**CITY OF SOMERVILLE, MASSACHUSETTS**  
**MAYOR'S OFFICE OF STRATEGIC PLANNING & COMMUNITY DEVELOPMENT**  
**JOSEPH A. CURTATONE**  
**MAYOR**

**Case #:** HPC 2018.037

## **PRESERVATION STAFF REPORT**

**Site:** 14 Flint Street

**PROPOSED**

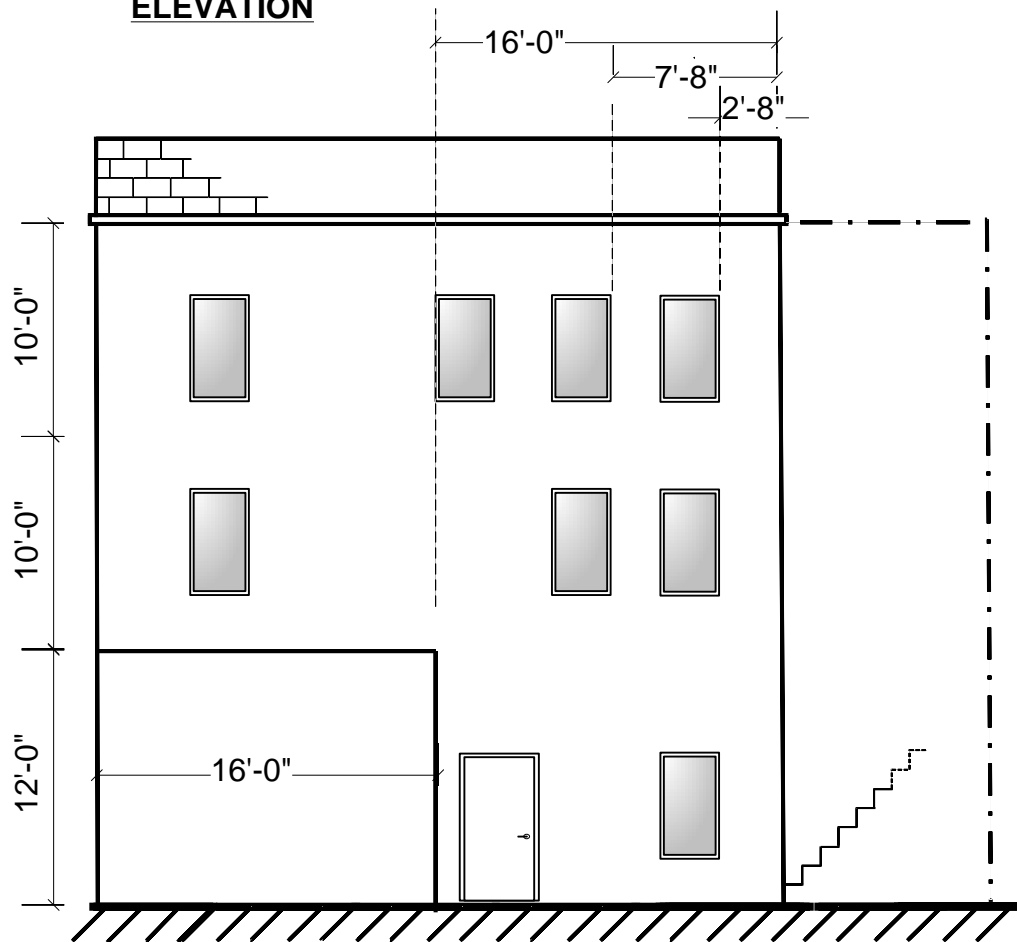
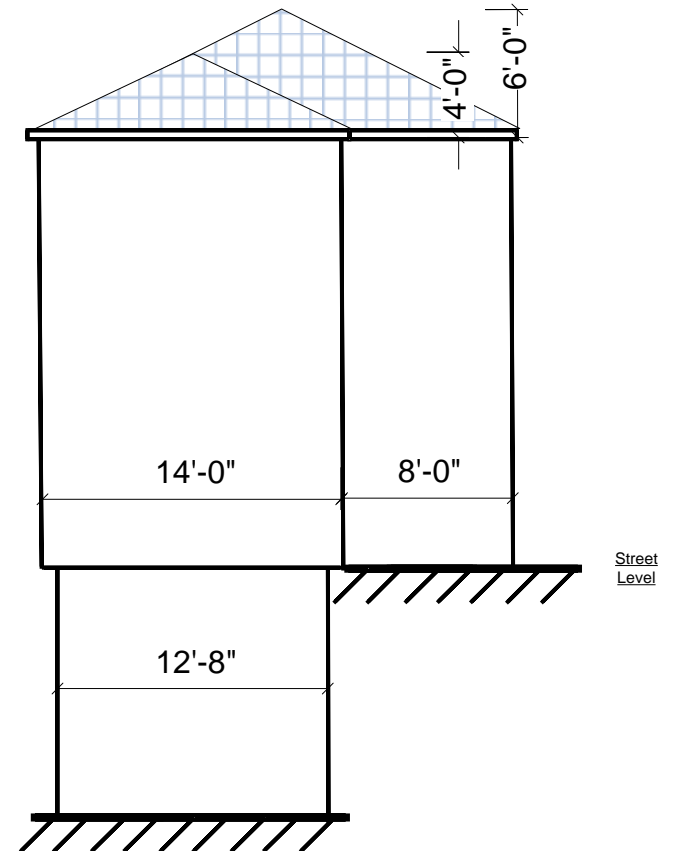
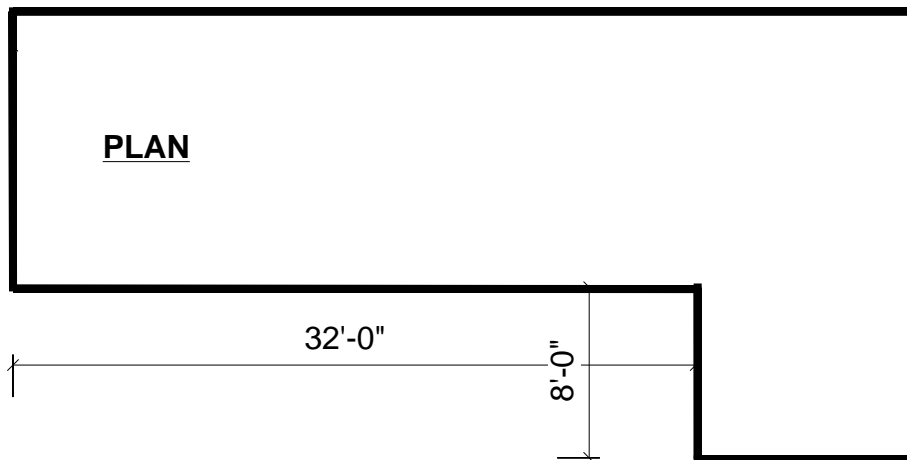
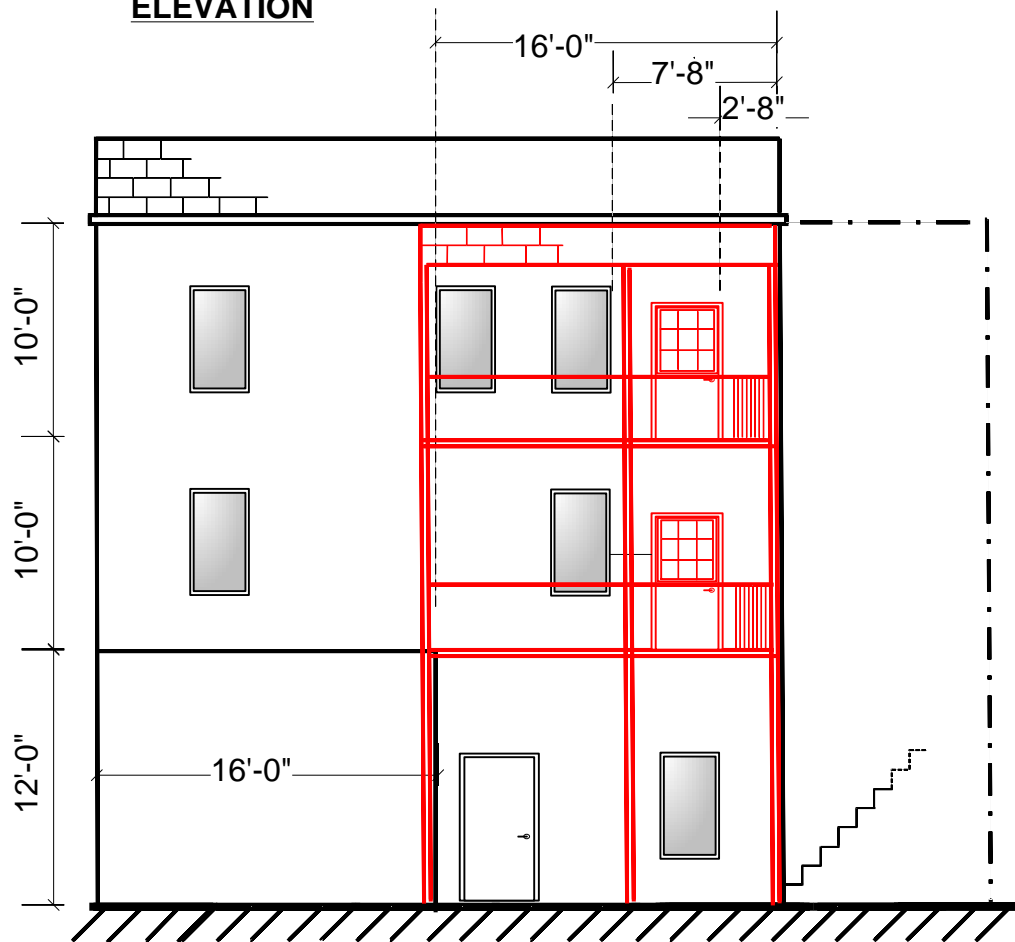
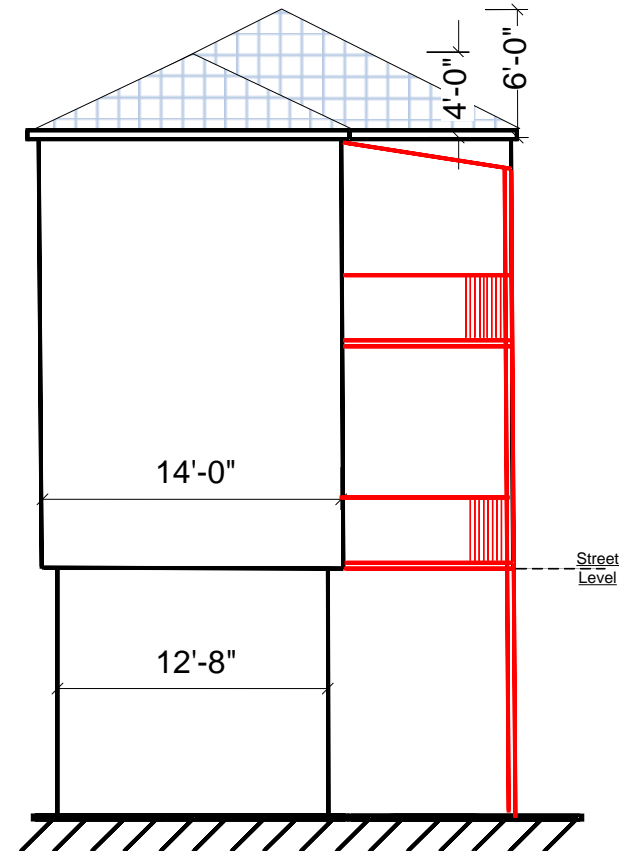
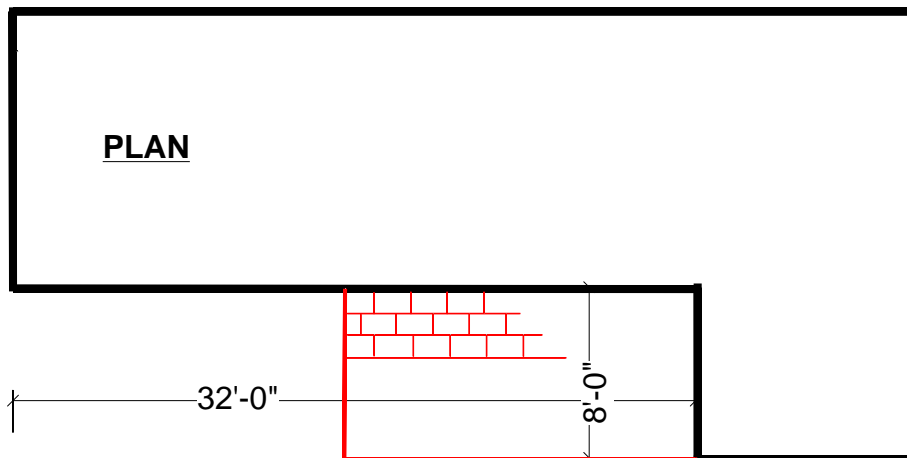
**Staff Findings** Staff finds that the proposed porches ~~do not~~ for the most part meet the HPC Guidelines. The ~~size and~~ location of the porches ~~are not~~ is traditional. Side or rear porches and piazzas may ~~span the width of a building or~~ fit into the inner corner between the main portion of the building and an ell. A humble home, such as this from circa 1857-58 would not have had porches well above the ground level. The Applicant has also made the porches smaller and related their size to the locations of the windows and basement door.

**Staff Findings:** Staff finds that the proposed alterations do not meet the above HPC Guidelines. The guidelines and considerations clearly state that windows should not be altered to become doors nor vice versa. While occasionally new opens are made in the envelope of a building, these relate to the rest of the windows and doors on a façade. In this case, windows to be altered are minimally to not visible from Flint Street or Franklin Street and visible from a distance from Oliver Street.

3. New porches shall be constructed on the inner corner of the building to the left rear of the main block.
4. The porches shall be covered with roof and detailed to relate to the rest of the building.

5. The porch posts shall be a minimum of 6 x 6 and shall not be pressure treated wood unless ~~hidden behind a porch skirt.~~ wrapped with a hard wood.

- ~~6. The porch skirt shall be constructed of wood and shall have either vertical slats or horizontal or diagonal lattice.~~
- ~~7.~~ 6. The porches shall be 8' x ~~12~~ 16' in size.

- ~~8.~~ 7. Top and foot rails should be generic.
- ~~9.~~ 8. The balusters may be plain or turned.
- ~~10.~~ 9. Two doors shall be added the rear block onto the porches.

- ~~11.~~ 10. The doors shall have 6 lights over panels in similar proportions to the approved windows.
- ~~12.~~ 11. Historic Staff shall issue a sign-off upon completion of the project that this was done in accordance with the Certificate and approved plans.
